Well Name: POKER LAKE UNIT 28-21 BS	Well Location: T25S / R31E / SEC 28 / NENE /	County or Parish/State:
Well Number: 156H	Type of Well: CONVENTIONAL GAS WELL	Allottee or Tribe Name:
Lease Number: NMLC062140A	Unit or CA Name: POKER LAKE	Unit or CA Number: NMNM071016X
US Well Number: 3001548958	Well Status: Approved Application for Permit to Drill	Operator: XTO PERMIAN OPERATING LLC

Sundry ID: 2635284

Procedure Description: **Surface Location Move, Spacing, Casing/Cement, Drilling Variance Changes XTO Permian Operating, LLC requests permission to make the following changes to the original APD: No Additional Surface Disturbance Change SHL fr/536'FNL & 1230'FEL to 536'FNL & 710'FEL. Well Stays in the Same Quarter-Quarter as Permitted Total SHL Move: 520' East SHL change requested to optimize well pad layout, drilling efficiencies, and for safety purposes. Change BHL fr/50'FNL & 1240'FEL to 2617'FSL & 792'FWL, Section 16-T25S-R31E Casing/Cement design per the attached drilling program. Attachments: C102 Drilling Program Directional Plan Multibowl Diagram

WELL LOCATION AND ACREAGE DEDICATION PLAT

30" x 11-3/4" x 7-5/8" x 5-1/2" MBU-3T-SF SOW Wellhead System
With 13-5/8" 10M x 7-1/16" 15M CTH-DBLHPS-SB Tubing Head
And 7-5/8" & 5-1/2" Fluted Mandrel Casing Hangers

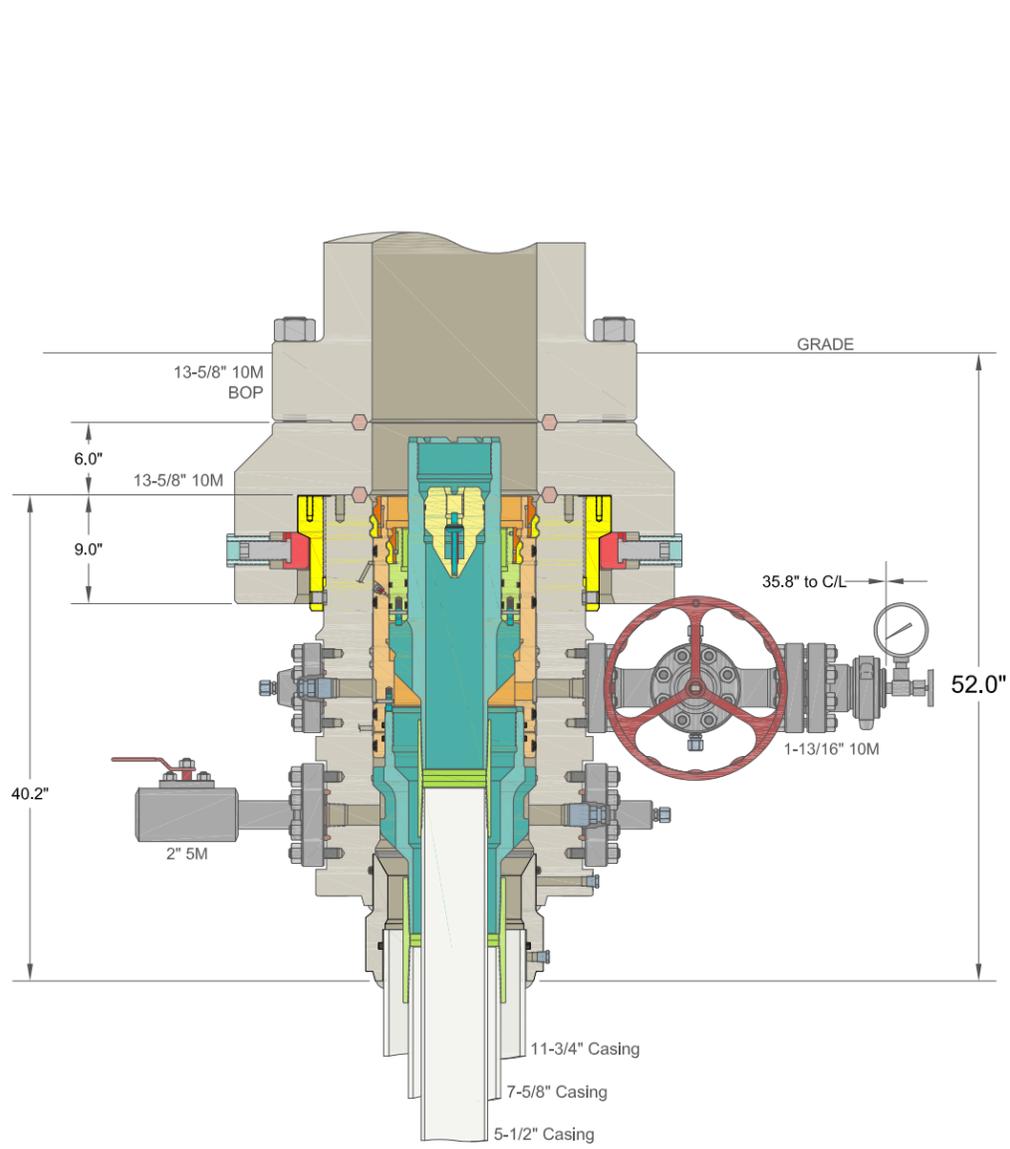
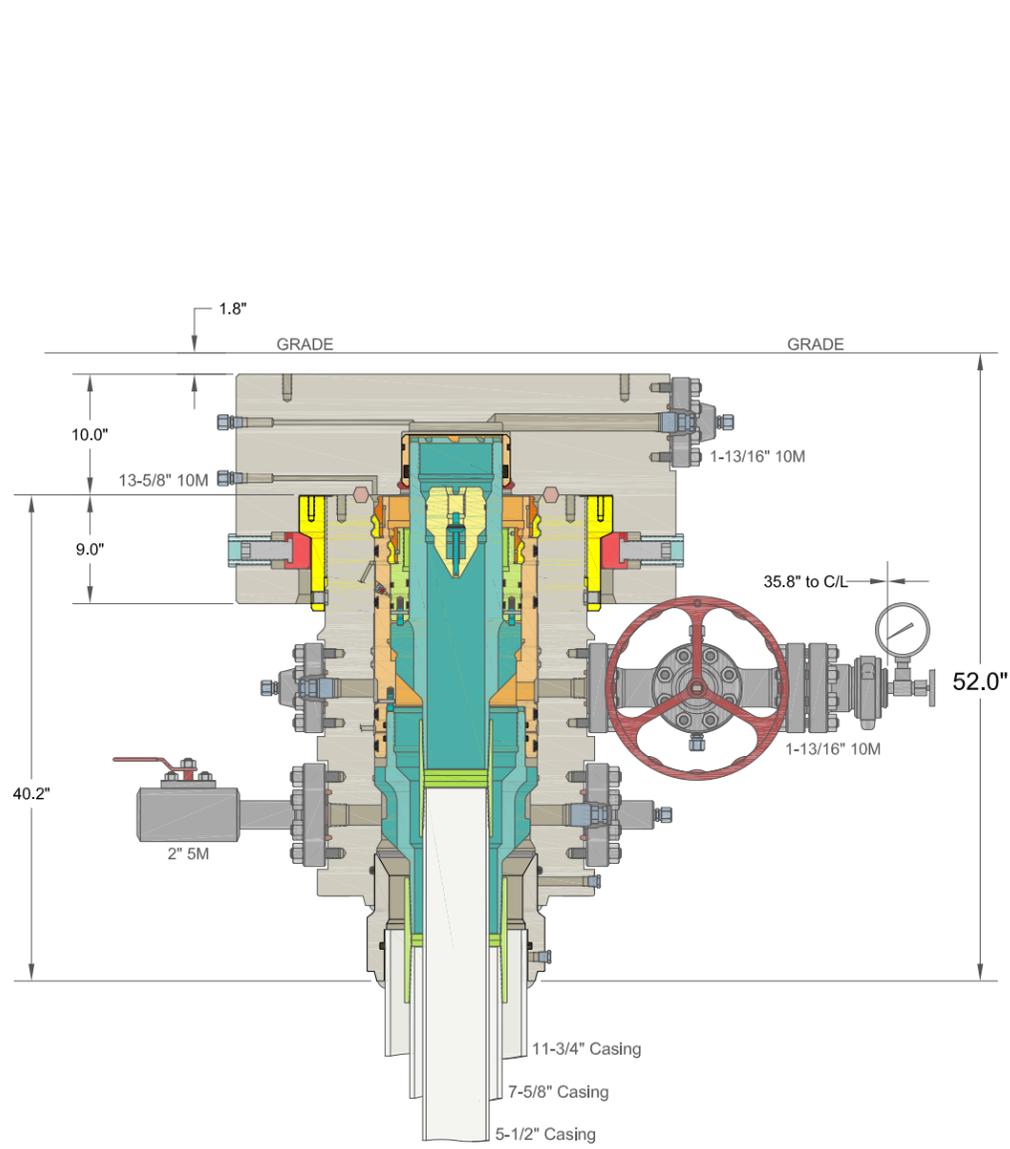
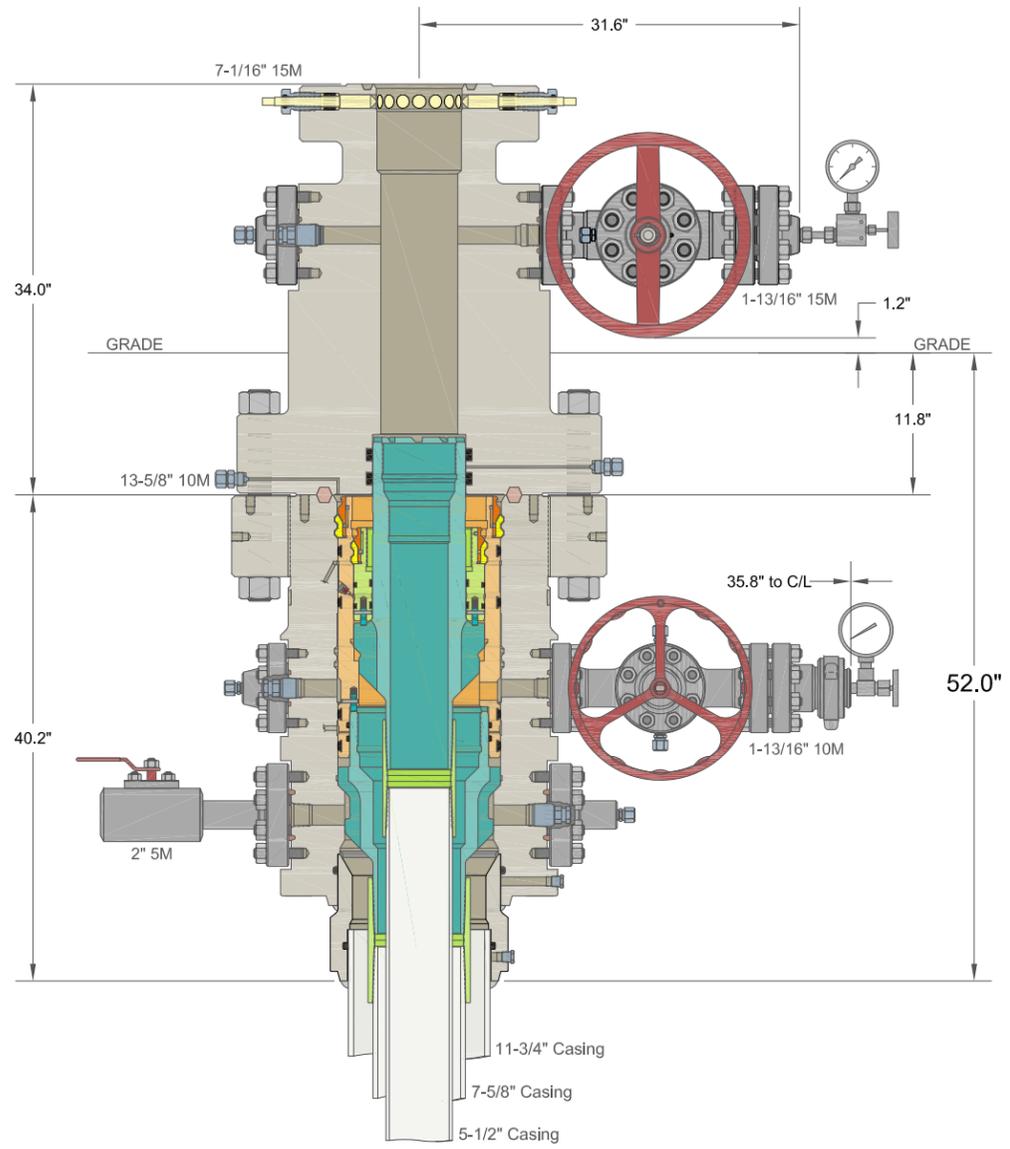
Permanent Wellhead – Multibowl System

A. Starting Head: 13-5/8" 10M top flange x 11-3/4" SOW bottom

B. Tubing Head: 13-5/8" 10M bottom flange x 7-1/16" 15M top flange

- Wellhead will be installed by manufacturer's representatives.
- Manufacturer will monitor welding process to ensure appropriate temperature of seal.

- Operator will test the 7-5/8" casing per BLM Onshore Order 2
- Wellhead Manufacturer representative will not be present for BOP test plug installation

1. Operator has proposed a multi-bowl wellhead assembly. This assembly will only be tested when installed on the surface casing. Minimum working pressure of the blowout preventer (BOP) and related equipment (BOPE) required for drilling below the surface casing shoe shall be **5000 (5M)** psi.

- a. Wellhead shall be installed by manufacturer's representatives, submit documentation with subsequent sundry.
 - b. If the welding is performed by a third party, the manufacturer's representative shall monitor the temperature to verify that it does not exceed the maximum temperature of the seal.

- c. Manufacturer representative shall install the test plug for the initial BOP test.
 - d. If the cement does not circulate and one inch operations would have been possible with a standard wellhead, the well head shall be cut off, cementing operations performed and another wellhead installed.
